Submission 04 - Mike and Tess Fitzgerald

Submission on Plan Change 1

2. This is a submission on Plan Change 1 to the Central Hawke's Bay District Plan – Operative in Part (2024)

Figure 1: Structure Plan Area B and Submitters sites.

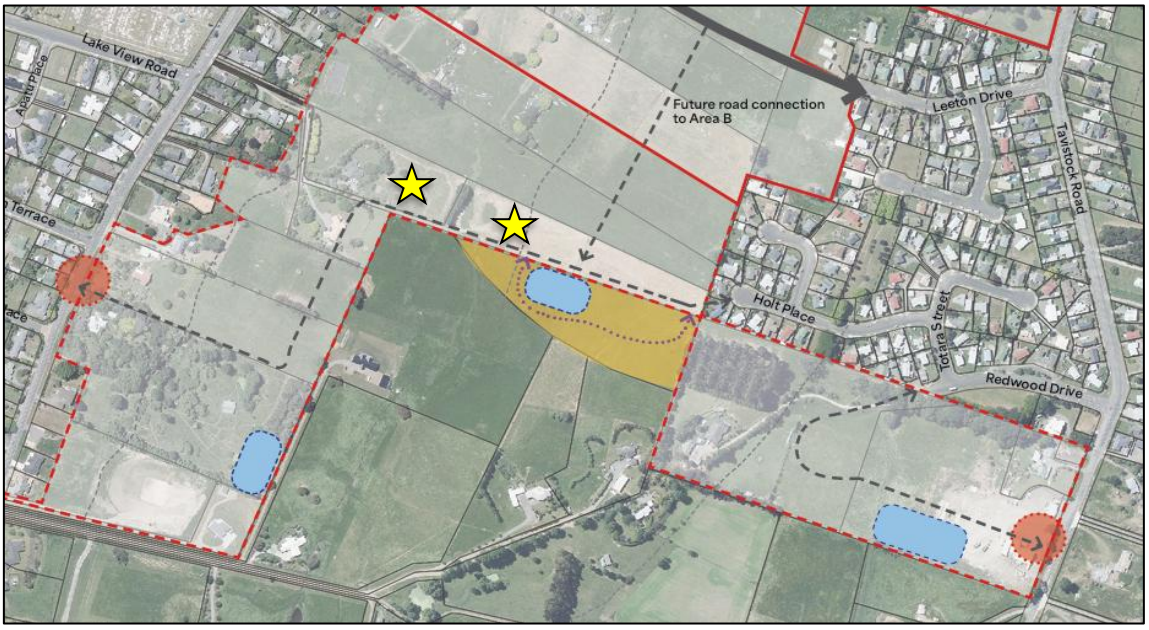
Under the Structure Plan the sites are shown as being traversed by future road, extending southward from Area A, with an east-west alignment through the sites, linked via and adjacent residential property, not within the Structure Plan boundary area, and connecting to Holt Place. A road connection extends to the southwest of the submitters sites onto Porangahau Road.

A stormwater management area is shown on Council-owned land adjacent to the sites southern boundary. The Council-owned land is not within the Structure Plan area boundary and is shown to support an Area B stormwater management area and a future recreation path.

1. A closer investigation indicates that the Holt Place residential site has inadequate shape factor to support a road linkage at the required legal width.

2. As the residential site is not within the Structure Plan boundary area, there is no compulsion for the owner to provide legal access.

3. These residential sites are not within the greenfield development area and the road connectivity through to Tavistock Road, is not an outcome associated with Greenfield development that can be enforced by Council.

4. The suitability for directing Area B traffic through to Tavistock Road via residential streets Holt Place and Totara Street is questioned. And, without direct Structure Plan support, residents along Holt Place and Totara Street may be considered affected parties due to additional vehicle movements, in what are both quiet low-volume streets with limited catchments and no 'through traffic'

i) That, if the Holt Place residential property access is to be retained, the Structure Plan area boundary be modified to account for the two residential sites at 25 and 26 Holt Place, so as to enable an enforceable access with sufficient dimensions, to accommodate a through access road connecting to Holt Place.

ii) Remove the road connection to Holt Place (via the residential sites) and provide a new road connection across the '*Council-owned land*', and across the sites at 1, Redwood Drive, connecting to the indicative road linking at Redwood Drive, and the new Tavistock Road intersection. The proposed road linkage is shown in yellow in Figure 2.

iii) Alter the Structure Plan Area B boundary to include the Council owned land.
